Date: 20/08/2024
Your ref: APP/X5210/W/24/3344559
Our refs: 2020/3500/P
Contact: Jaspreet Chana
Direct line: 020 7974 1544
Email: Jaspreet.Chana@camden.gov.uk

Site: 13-16 Guilford Street, London, WC1N 1DX
Appeal by: Mr Anthony O Sullivan

Proposal: External alteration to involve opening up of lower ground floor lightwell and retention of existing railings at ground floor level (part retrospective)

Fig.1. Site location plan screen shot

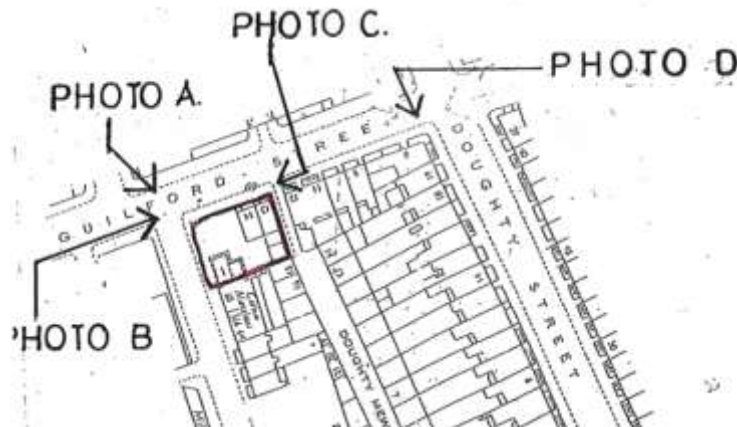
5. The applicant refers to a land registry document that shows the paved area in private ownership.

The council notes that the land registry document that the appellant is referring

to shows the site outlined in red. This site location plan is indicating where photos are being taken from not the extent to where the lightwell is being extended out. Please see below:
